Evaluation of proposed move for Water Right No. 3714

Proposed: Move water right no. 3714 to a new well location, 1,065 ft to the southeast.

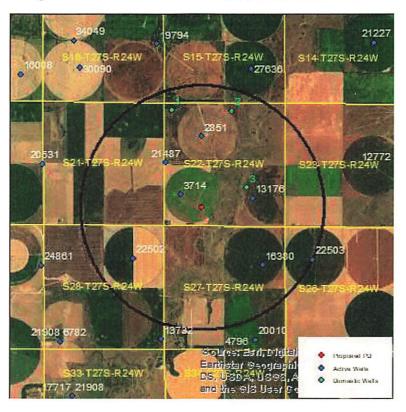
Wells within 1 mile: 21487, 2851, 13176, 22502, 16380, and three domestic wells, numbered on the above map.

Net drawdown exceeds the drawdown allowance for water right numbers 2851, 13176, 22502, 16380, and domestic wells numbered 2 and 3 on the map. These wells are all critical because the remaining saturated thickness is only 46 ft, and the GMD3 hydrologic model projects a water table decline of an additional 15 ft over the next 25 years.

WELL TEST ANALYSIS

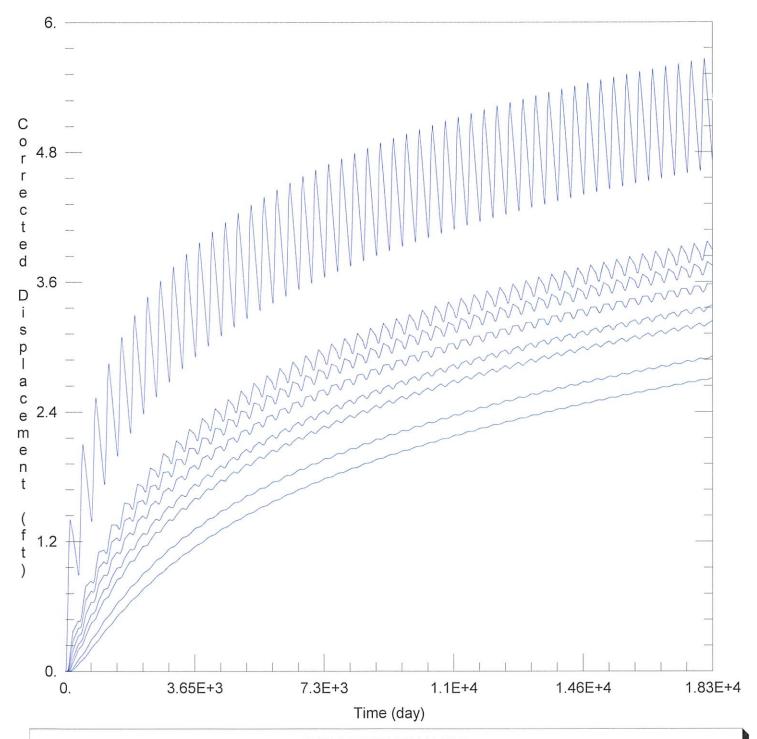
21487: Drawdown from current location = 5.66 ft

2851: Drawdown from current location = 3.97 ft

13176: Drawdown from current location = 3.58 ft

22502: Drawdown from current location = 3.38 ft

16380: Drawdown from current location = 2.71 ft

Domestic 1: Drawdown from current location = 3.23 ft

Domestic 2: Drawdown from current location = 2.91 ft

Domestic 3: Drawdown from current location = 3.78 ft

WELL TEST ANALYSIS

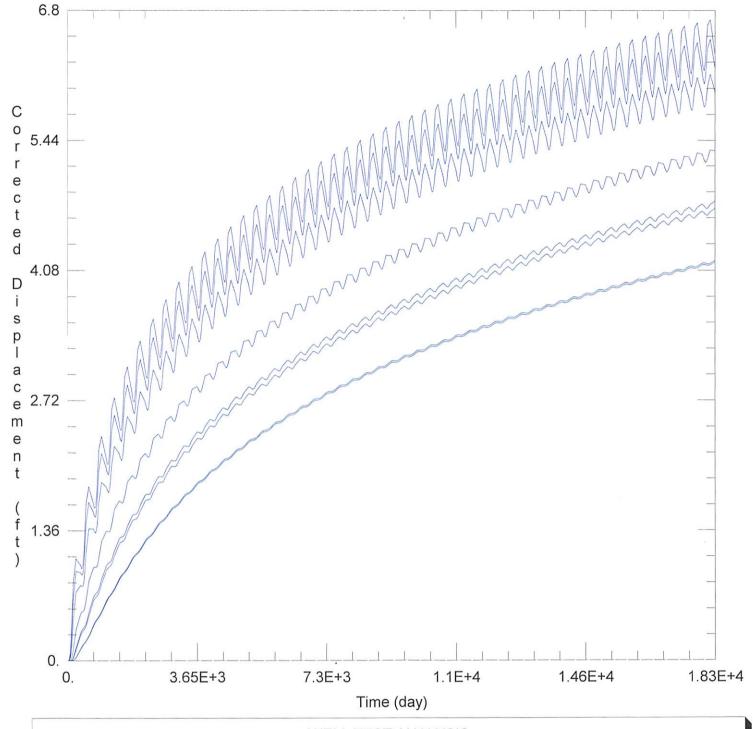
Drawdown from proposed location = 6.13 ft

Drawdown from proposed location = 5.34 ft

Drawdown from proposed location = 6.49 ft

Drawdown from proposed location = 4.72 ft

Drawdown from proposed location = 4.80 ft

Drawdown from proposed location = 4.16 ft

Drawdown from proposed location = 4.18 ft

Drawdown from proposed location = 6.70 ft
